# Lime Down Solar Farm

TRANSPORT: Report on behalf of  
Stop Lime Down (SLD)

Railton TPC Ltd ref:	Lime Down 01E
Planning Inspectorate	Ref: EN010168
Planning Authority	Ref: N/A
Date:	April 2026
Author:	Bruce Bamber BSc MA MSc MCIHT

## Plan 1: Public Rights of Way around Rodbourne

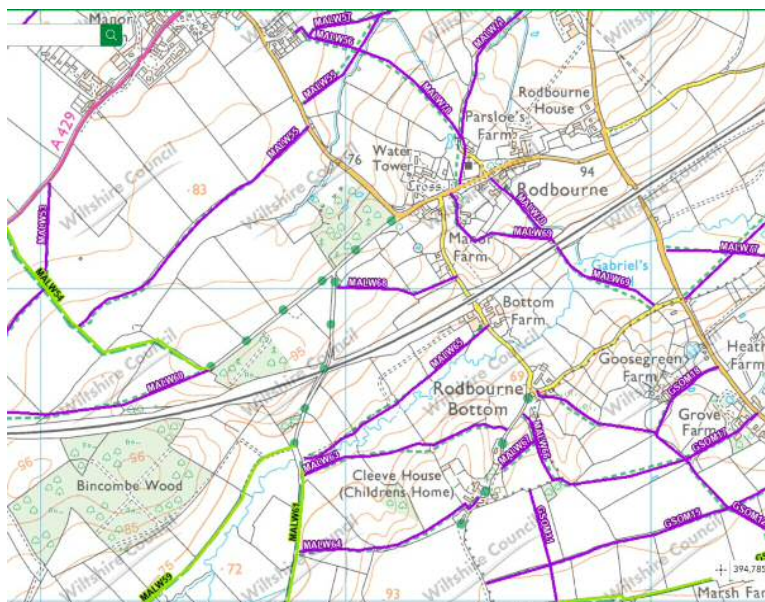
- 7.16 There are numerous ProWs in the vicinity of Rodbourne as is evident from this extract from the Wiltshire Definitive Map. ProWs are shown as purple lines:

- 7.17 The ProWs link to lanes to the south-west of the village. Despite the obvious potential for the lanes and ProWs to the west and south of Rodbourne to be used by local residents and others as recreational routes, the applicant fails to undertake any assessment of the potential adverse impacts of the construction activities related to Area E on these vulnerable highway users.
- 7.18 The Outline Public Rights of Way and Permissive Path Management Plan provides no specific mitigation for the ProWs in the vicinity apart from the proposal to temporarily divert PProW MALW54 at Access 18 (south-eastern side of A429).

**Figure 1: Transport Areas of Concern (northern area)**

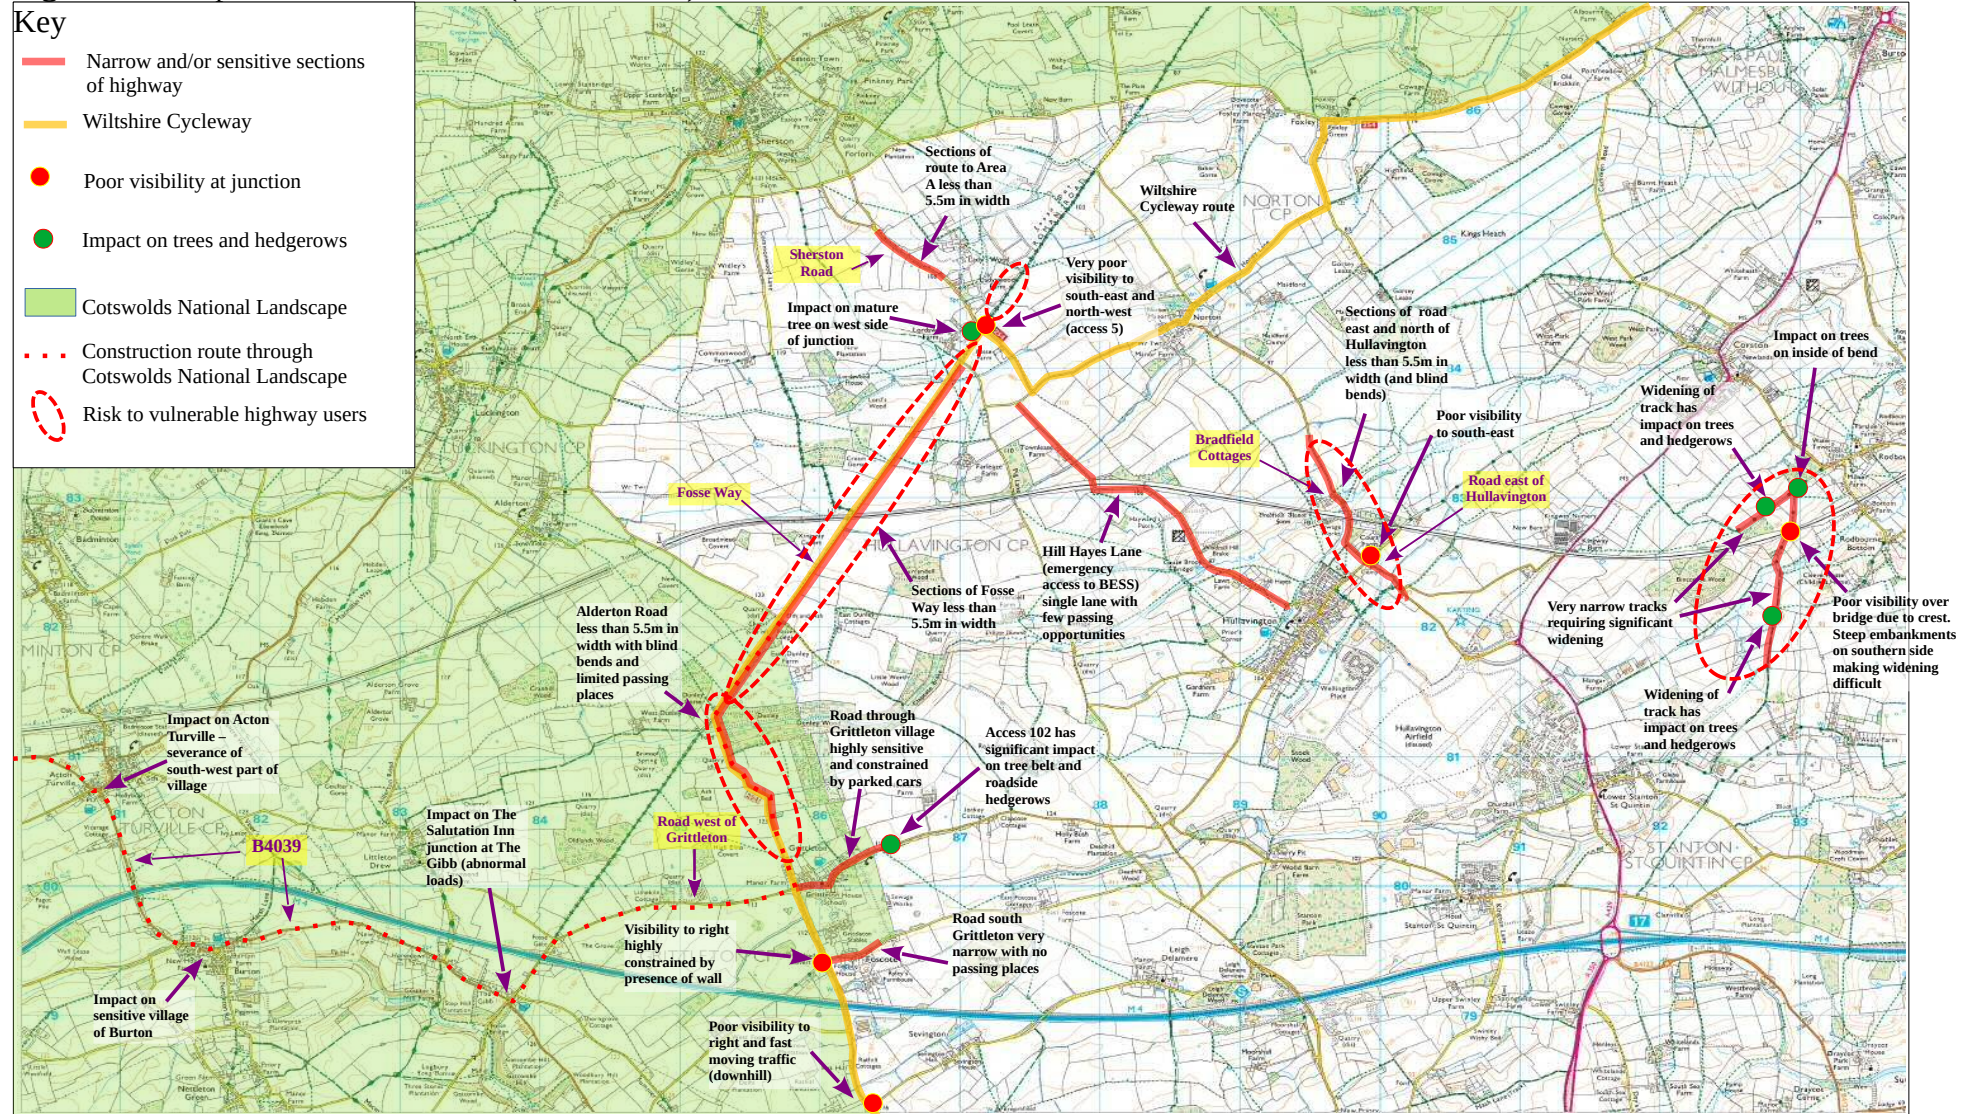
2.31 **Figure 1** identifies those sections of construction routes that are generally below 5.5m in width. As described above, HGVs cannot safely pass each other on roads less than 5.5m in width.

2.34 **Figure 1** identifies sections of rural lanes that are less than 5.5m in width. The areas include the Fosse Way, Alderton Road south of the Fosse Way, the road to Sherston north-west of the Fosse Way, the road east of Hullavington, lanes south-west of Rodbourne, the road through Grittleton and the road to the south of Grittleton.

- 3.10 **Figure 1** identifies two junctions south of Grittleton where visibility is very poor. The more northerly junction (Neeld Court) has very poor visibility to the north due to the presence of a dry stone wall. The more southerly junction also has poor visibility to the north due to a bend in the road and an embankment. Traffic approaching from this direction is travelling downhill at speed. Neither of these junctions provides safe visibility splays and there are therefore road safety concerns related to the intensification of their use during construction.

- 7.32 **Figure 1** shows that much of the Fosse Way, Alderton Road, the road to Sherston and the road east of Hullavington are all less than 5.5m in width. Not only would the substantial increases in HGV traffic on these routes lead to loss of non-motorised amenity and fear and intimidation, but would also lead to highway safety concerns.

10.1 **Figure 1** indicates the extent of the CNL. It is clear that the proposed construction route to and from Junction 18 of the M4 passes through the CNL.

**Figure 2: Transport Areas of Concern (cable route north)**

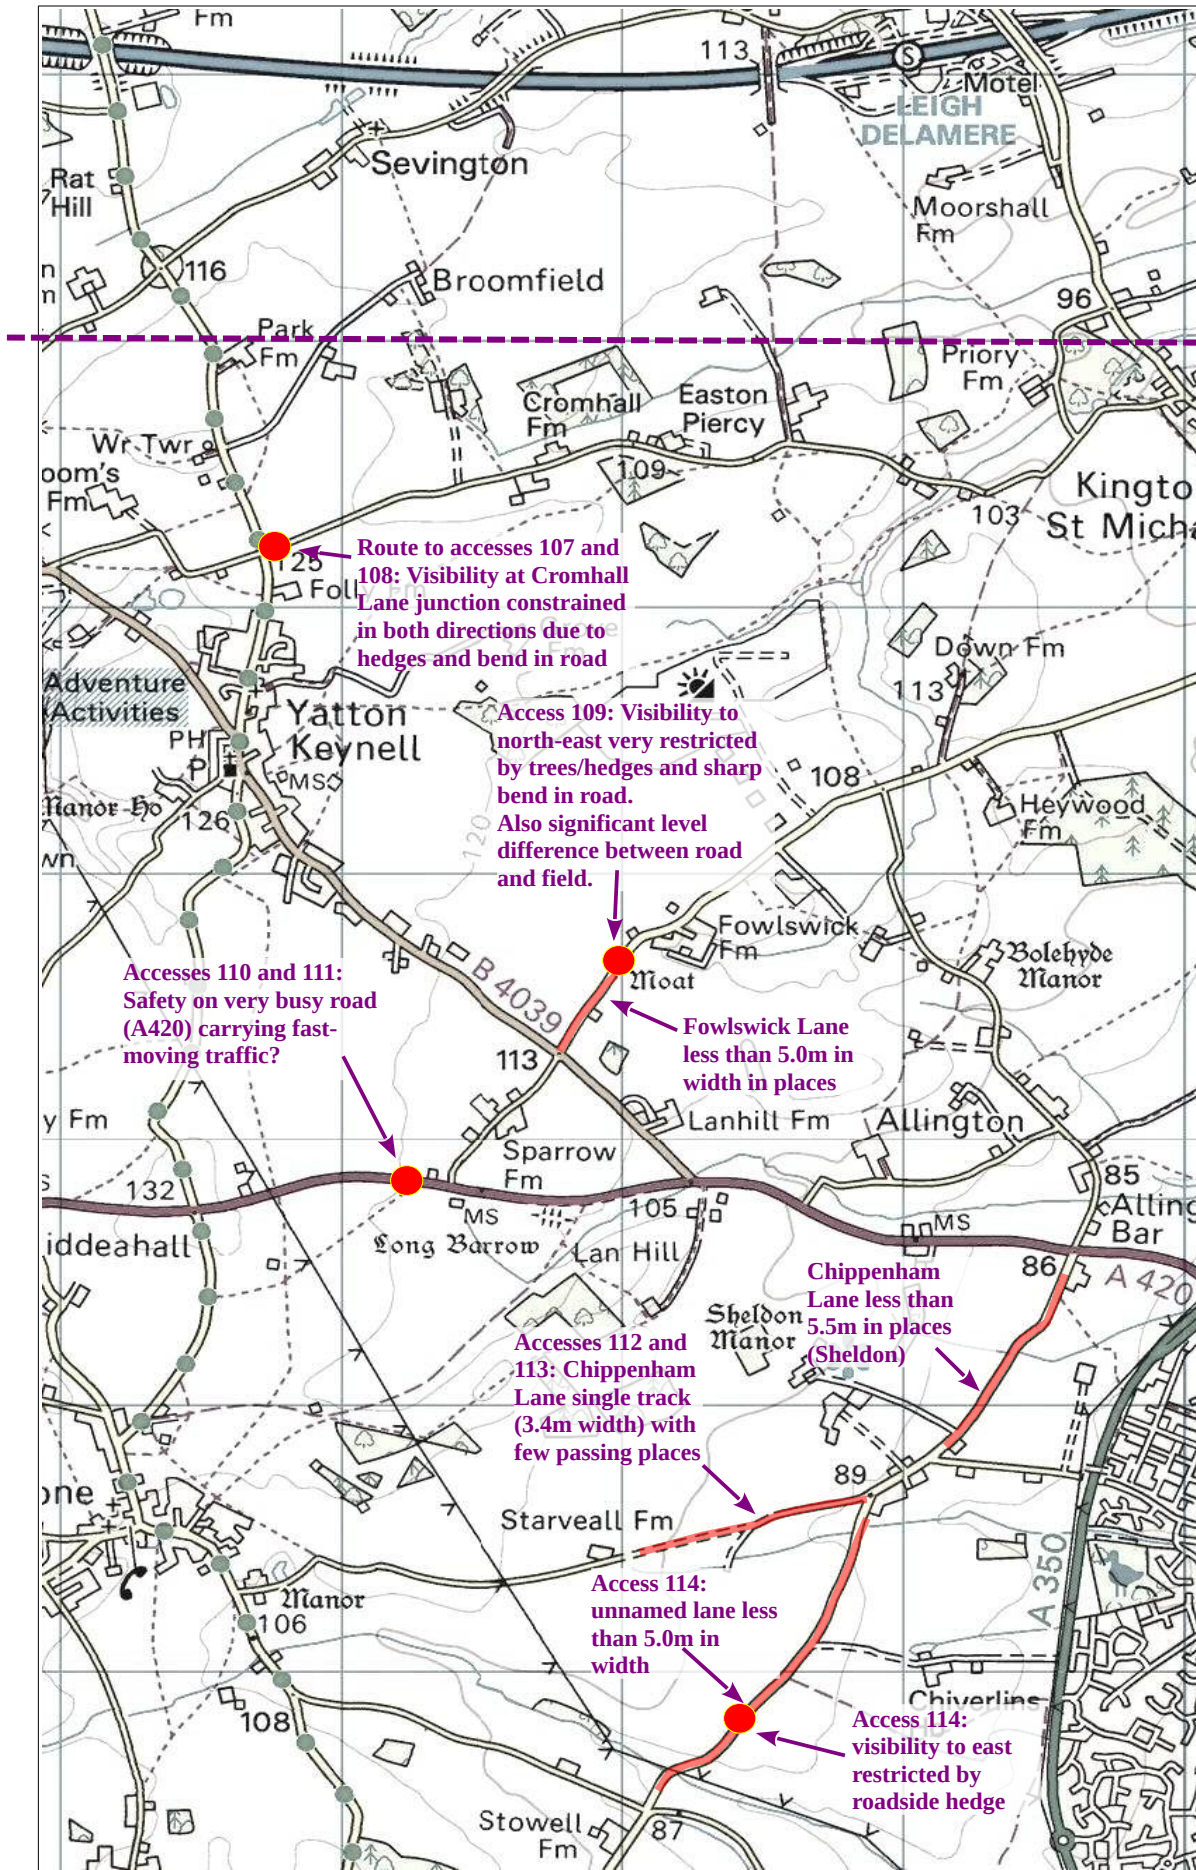
- 2.41 **Figures 2 and 3** identify a number highways concerns relating to the cable route corridor.
- 2.42 **Figure 2** identifies a section of Fowlswick Lane (Access 109) that is less than 5.0m in width in places and sections of Chippenham Lane that are as little as 3.4m in width. The lane to the south of Chippenham Lane (Access 114) is also less than 5.0m in width in places.

- 3.11 **Figure 2** indicates that the junction of Cromhall Lane with The Street that is on the route to Access 107 has poor visibility in both directions. There are therefore highway safety concerns related to the intensification of its use during the construction period.

**Figure 3: Transport Areas of Concern (cable route south)**

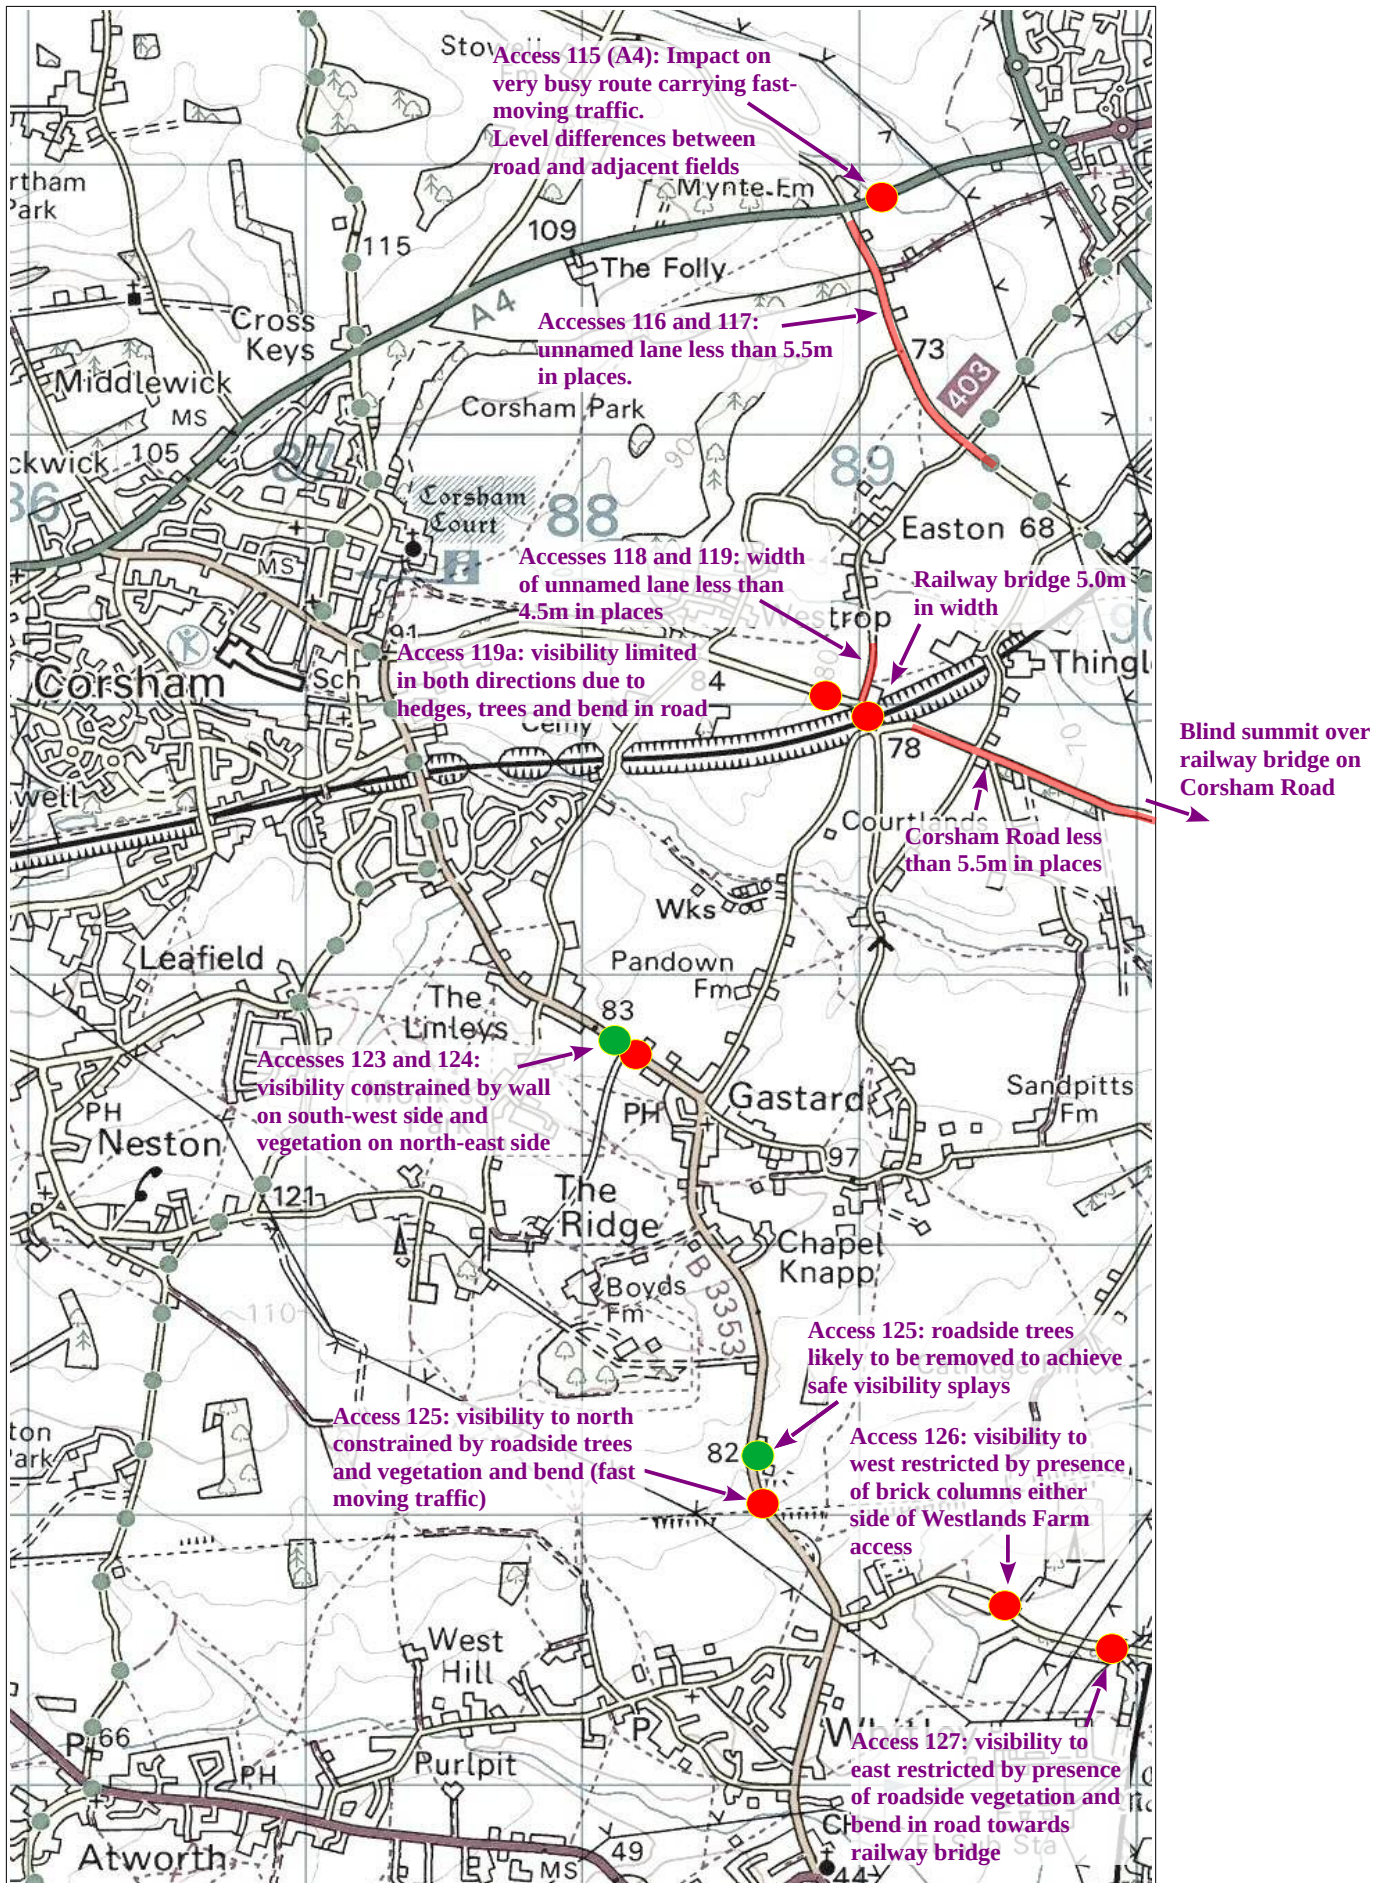
- 2.44 **Figure 3** indicates that the unnamed lane south of the A4, the unnamed lane north of the railway crossing (Accesses 118 and 119) and sections of Corsham Road are also less than 5.5m in width

**Appendix 7: Flow Diagram showing Revised Estimate of Construction HGVs**

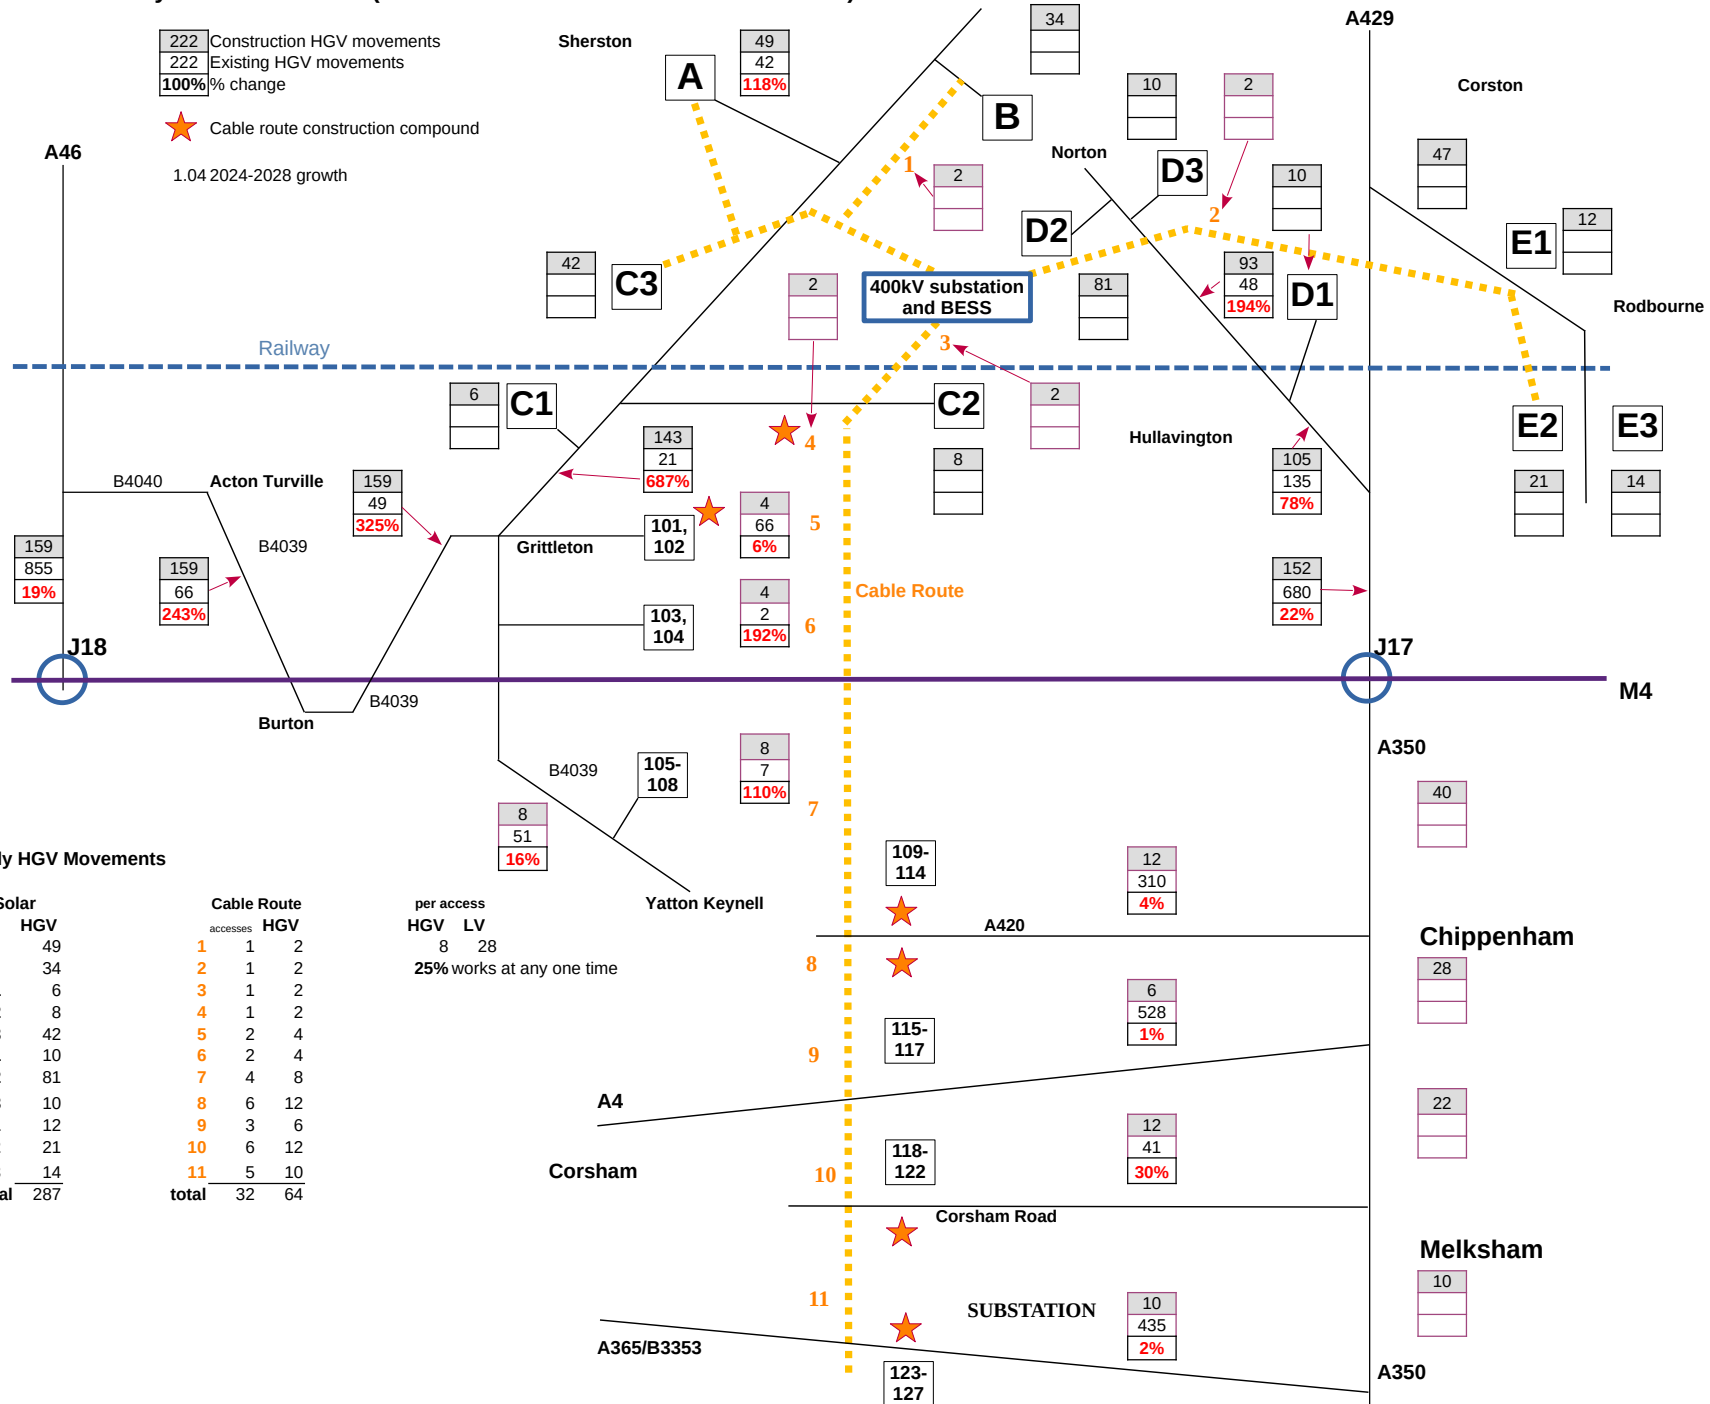
- 5.4 **Appendix 7** contains a flow diagram that assigns the revised estimate of HGV trip generation set out above to the highway network. The following table provides a summary of the increases in HGV flows derived using the applicant's and the revised assessment of trip generation. The locations are shown on **Figure 1**:

5.8 On the basis of the revised assessment of HGV trip generation the levels of impact increase significantly. The Fosse Way experiences more than a four-fold increase in HGV movements.
